CONNECTICUT YANKEE ATOMIC POWER COMPANY

Haddam Neck Plant
Proposed Revision to Technical Specifications
Steam Generators

Pursuant to 10CFR50.90, Connecticut Yankee Atomic Power Company (CYAPCO) hereby proposes to amend Operating License No. DPR-61 for the Haddam Neck Plant by incorporating the attached changes into the plant Technical Specifications. The proposed changes revise Technical Specification 4.10.1 - Inservice Inspection of Steam Generator Tubes to allow sleeving as a means to repair steam generator tubes and to include "pitting" as a mechanism causing steam generator tube degradation.

Figure 1: Cross-section of repaired steam generator tube

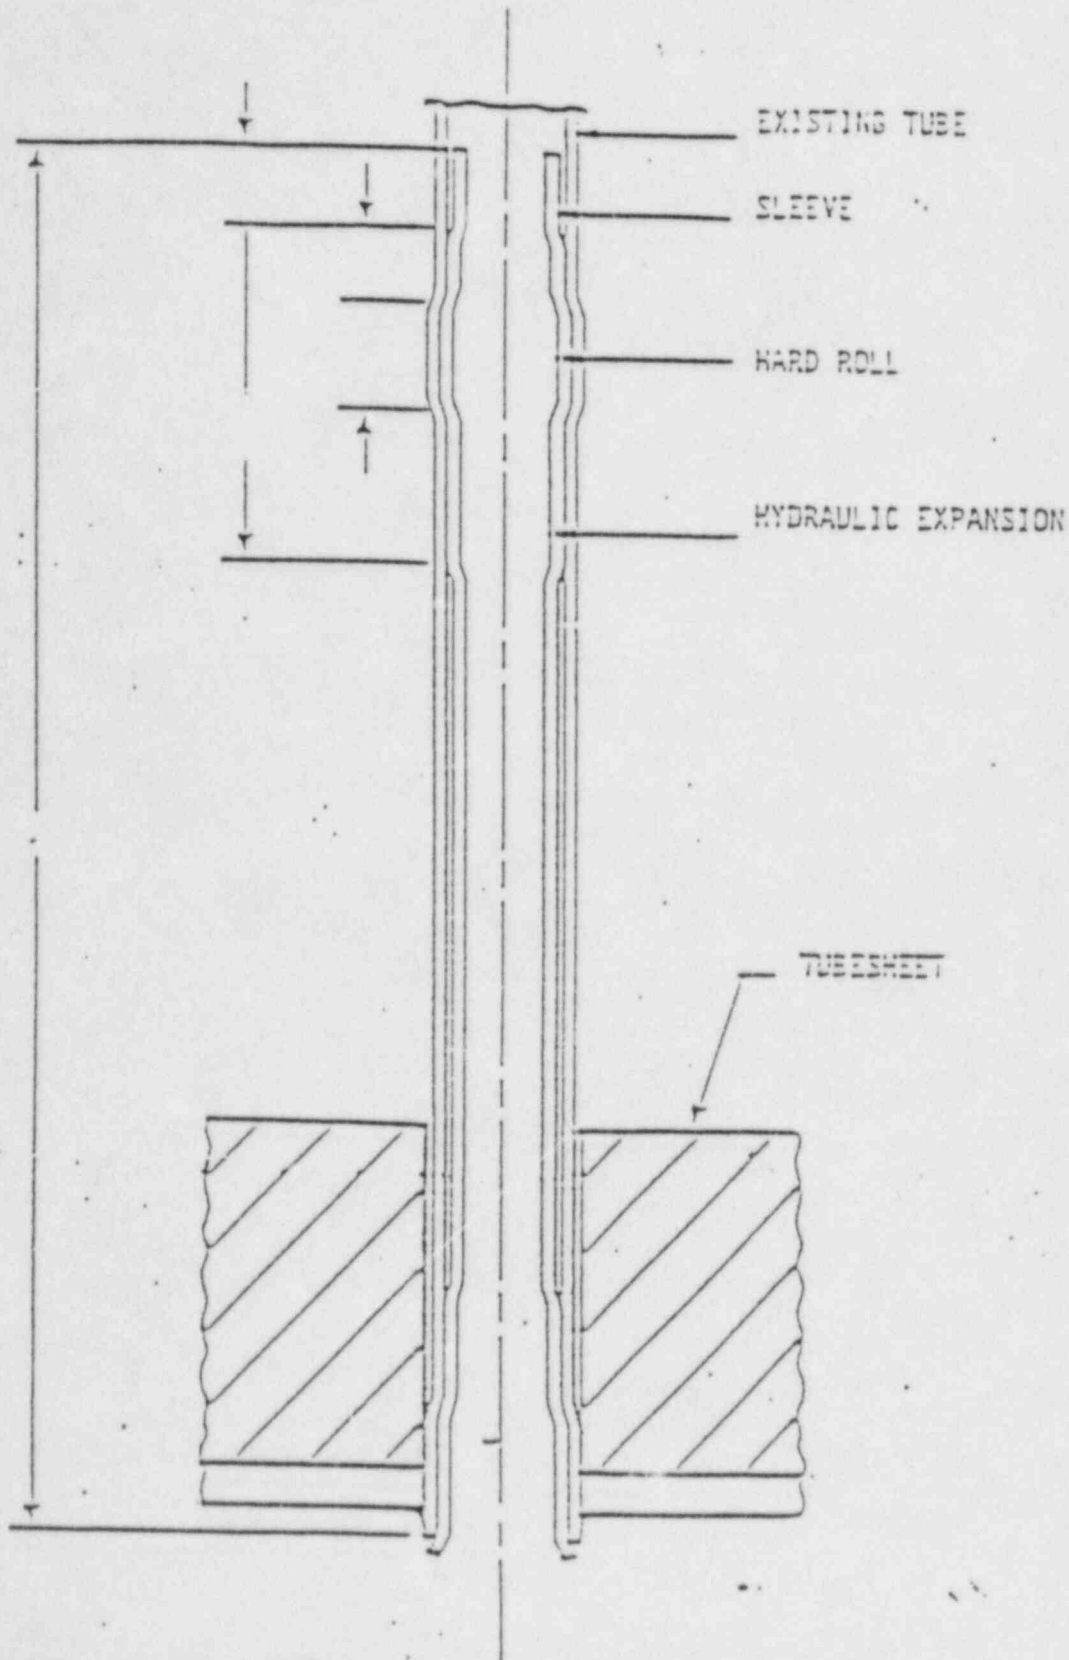
The repair process requires that sleeves be inserted inside defective steam generator tubes in a manner to completely span the defective tube region.

Plastic expansion of the sleeve against the tube, at the top and bottom of the sleeve, provides a leak limiting joint which exhibits sufficient mechanical strength to withstand normal operating, test and postulated accident loading conditions. Figure 1 shows a typical repair configuration. The expanded sleeve forms a new section of the reactor coolant pressure boundary.
